PLAN COMMISSION

Wednesday, May 13, 2026 – 6:30 PM

A. Review/Recommendation: Plan Commission review & recommendation on a Site Plan Review Application submitted by McMahon Associates on behalf of Chris & Brittany Voigt for a new equestrian building located at 3411 Winnegamie Dr.
B. Review/Recommendation: Plan Commission review & recommendation on revisions to the definitions of "farm" and "residential" within the A-2 zoning district in the Town Zoning Ordinance.
C. Discussion/Action: Plan Commission review & consideration of Resolution 2026-006 Recommending Amendments to Chapter 7.10 Subdivision Ordinance.

From: Administrator/Staff
To: Plan Commission
Re: Plan Commission review & recommendation on a Site Plan Review Application submitted by McMahon Associates on behalf of Chris & Brittany Voigt for a new equestrian building located at 3411 Winnegamie Dr.

NEW EQUESTRTIAN BUILDING: LEGACY ROSE FARMS
TOWN OF CLAYTON, WINNEBAGO COUNTY, WI
LANDSCAPE PLAN

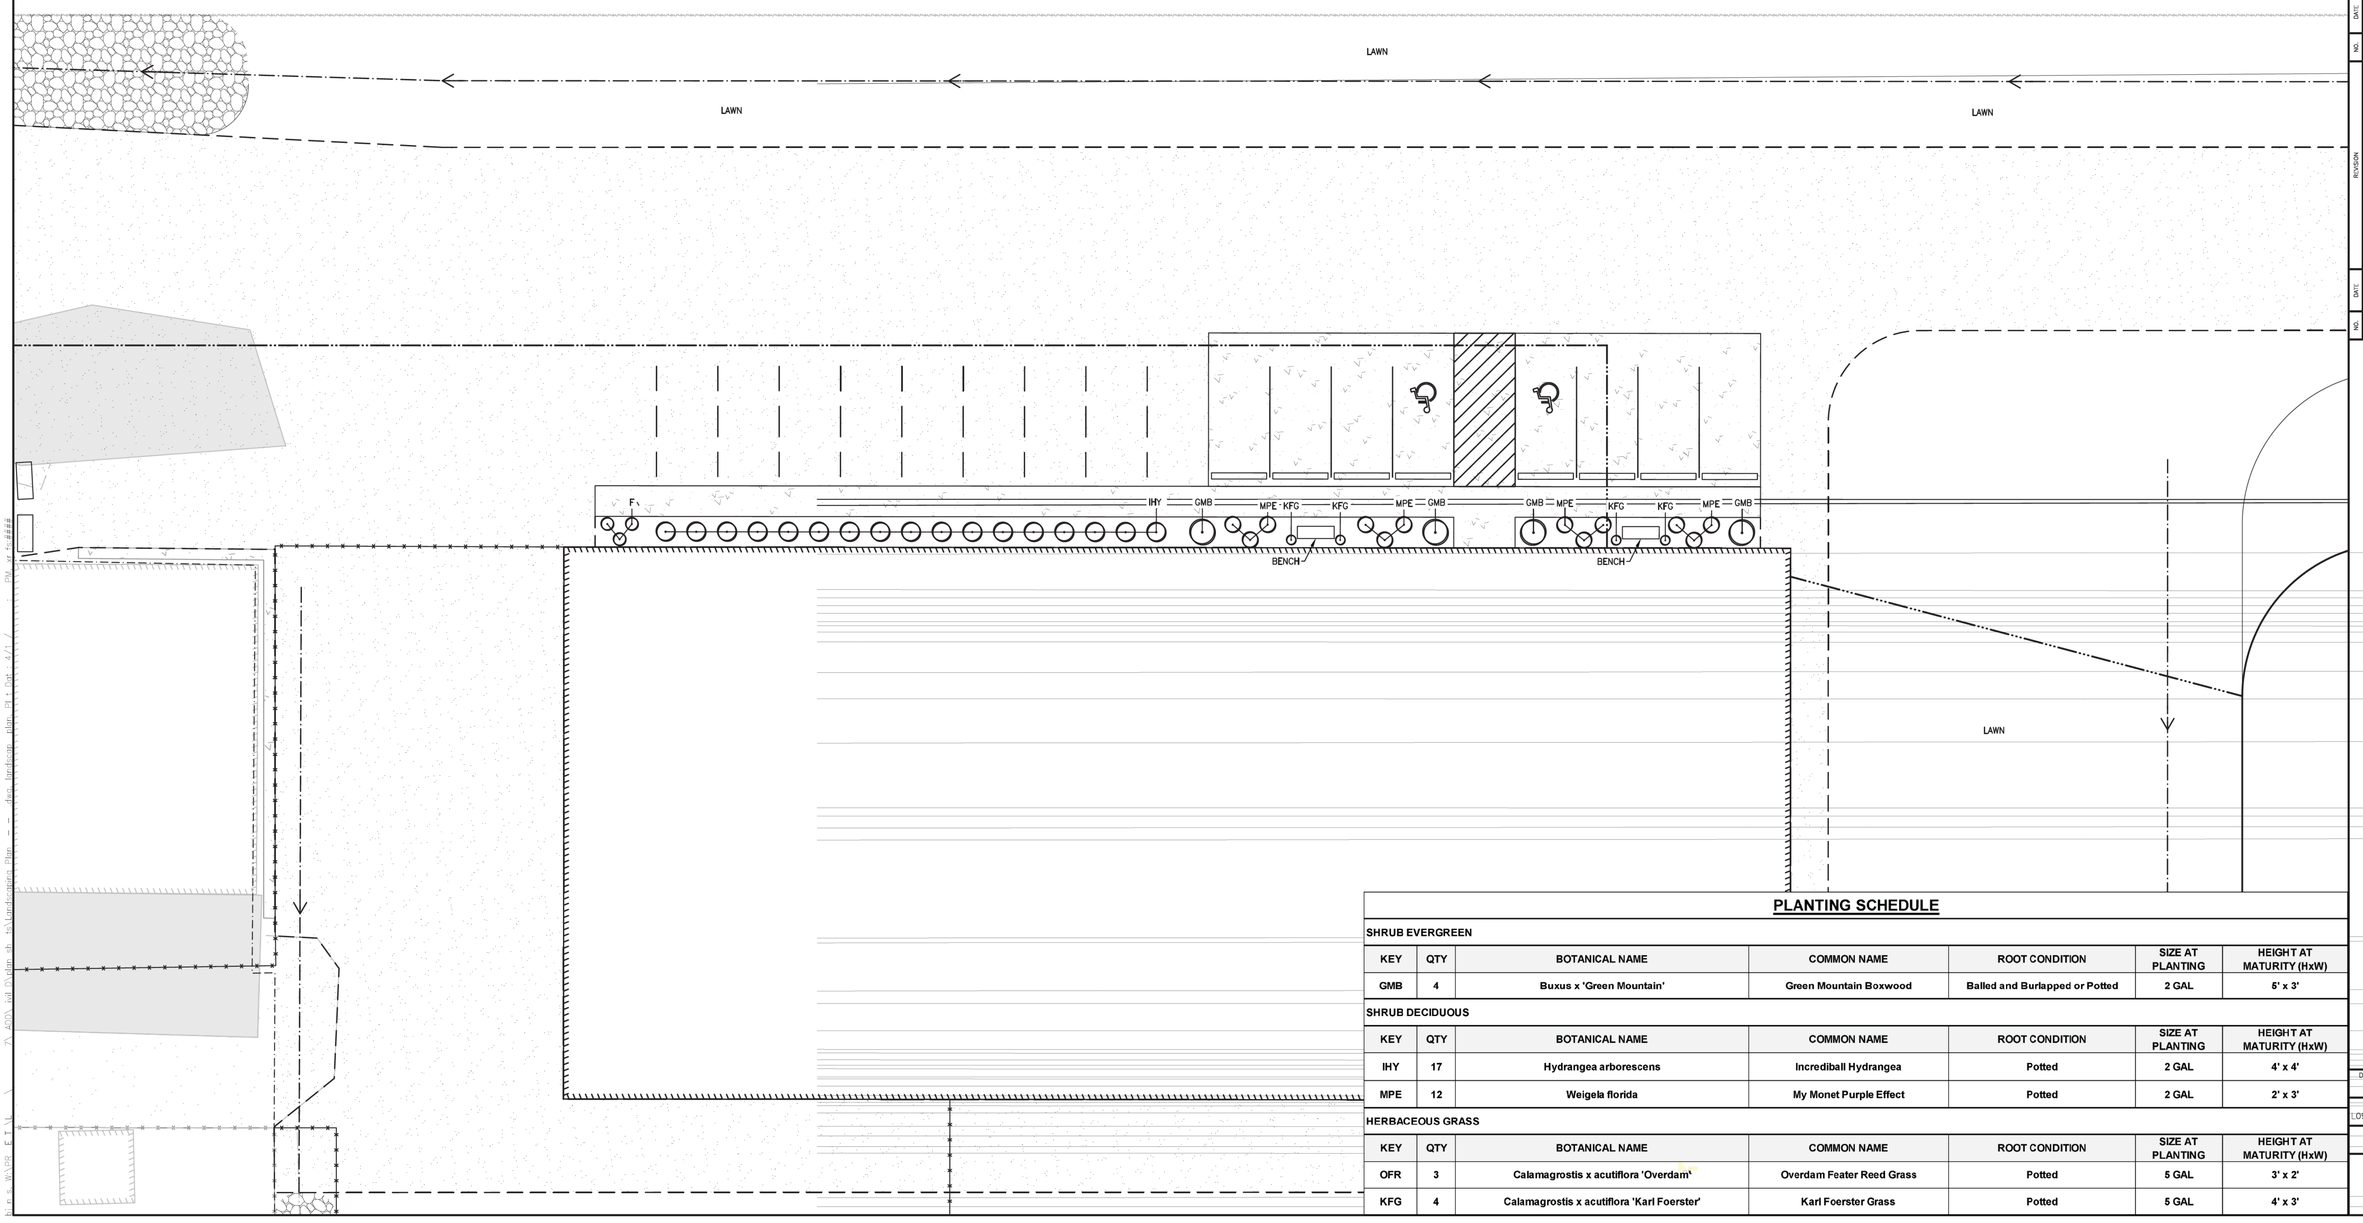
Attachment E contains the landscaping requirements. Under the ordinance, residences are not allowed on the site of commercial stables. The landscaping of the home may be considered relevant to this Site Plan review only as it pertains to the visibility from the road right-of-way. Alternative compliance is an option offered to applicants under Attachment E, E. Alternative compliance standards require the applicant to demonstrate how the intent of the landscaping standards can be met more effectively through alternative means. The Town can further waive or modify the requirements when good cause is shown by the applicant as allowed in Att. E, F.(1).

Parking lot landscaping has two parts, the screening from view from off-site, and the intermittent placement in the parking area of islands or peninsulas. Parking lot screening is likely covered by the buffer yard landscaping and alternative compliance requested there. The applicant asks for a reduction in the parking area landscaping standards, due to the siting of the building far from the road and the incompatibility of the use with aesthetic vegetation. Applicant's letter states safety reasons (horses spooking or attempting to ingest the plantings) and the space being otherwise needed for maneuvering of trailers, accessible vehicles, and accessibility supports.

Town of Clayton Zoning Code of Ordinance:
Chapter 9 -Town of Clayton Zoning Code of Ordinances – Attachment E Landscape Design Standards
Section C. Design Standards:
Code in which alternative compliance is requested:
" (b) Parking Lot Landscaping
1.a) Parking spaces must be separated by a planting island or peninsula at the rate of one island/peninsula for each row of twelve (12) consecutive parking spaces for a single row configuration…"

For these reasons, and in conjunction with the additional building-side landscaping being proposed, Legacy Rose Farms respectfully requests alternative compliance from the parking-lot landscaping requirement. See plan sheet 08 and site photos.

b. Acceptance of the provided building landscaping plan for the east aspect of the building.
   c. No additional parking lot landscaping is required.

EXTERIOR BUILDING ELEVATIONS

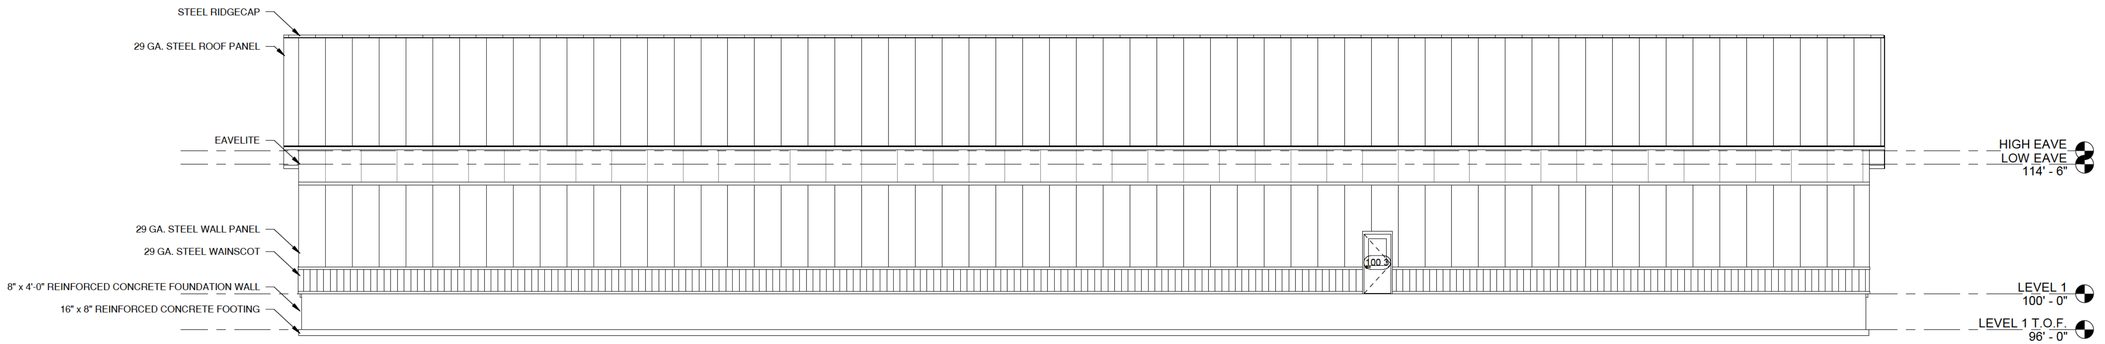
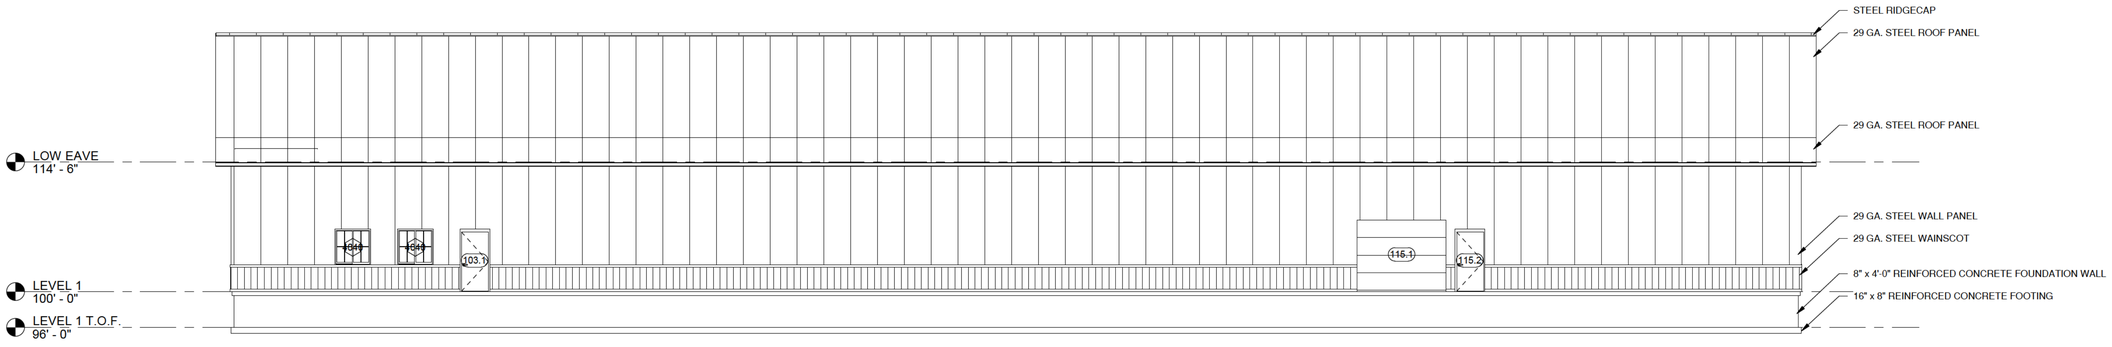
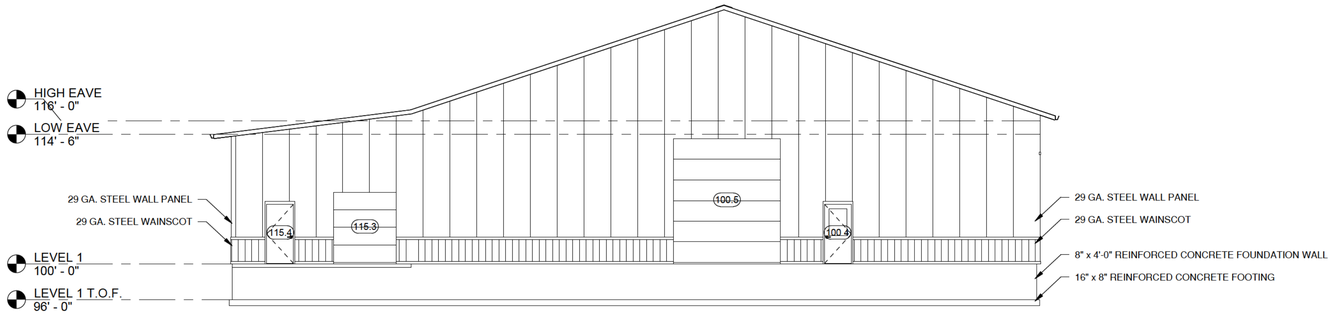
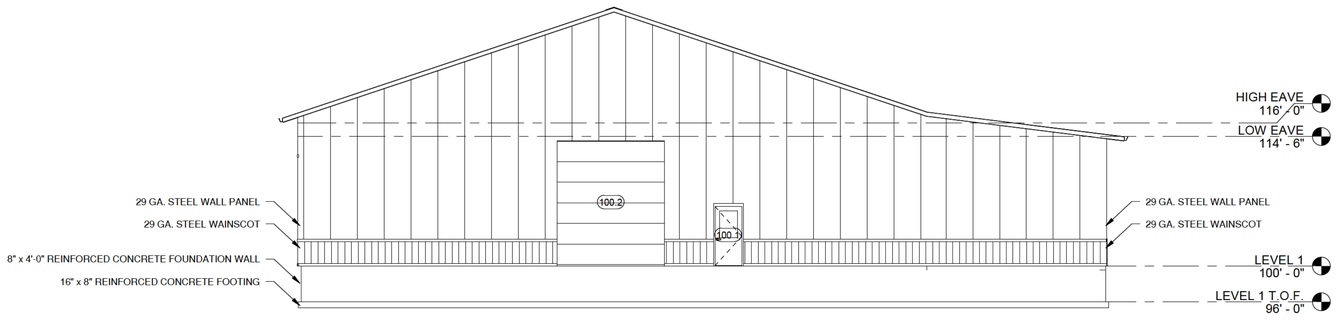
Attachment C describes the Architectural Design Standards, and **Attachment D** shows the extent of each tier. The site is within the Tier 2 Rural Transition design zone, and at least 50% of exterior wall surfaces facing street and side yards must be covered by acceptable exterior building materials. Rear yard facing aspects shall be covered by 33% or more of said materials. While steel panels are not listed under Acceptable Exterior Building Materials in Attachment C .(1)(d) , other materials can be approved by the Town Board. Steel panels are planned for the roof, and have both a 4:12 and <2:12 slope planned for sections of the building. The SRI must be at least 78 or higher for the <2:12 slope, and at least 29 on the 4:12 slope areas. No values were provided for the planned material by the applicant.

5. Applicant shall provide SRI values for the building materials. Values must meet the Town minimum standards as described in Attachment C.
6. All landscaping required in this approval shall be installed within six months of occupancy of the building. Extensions to this timeline must be done through specific approval by the Town Board.
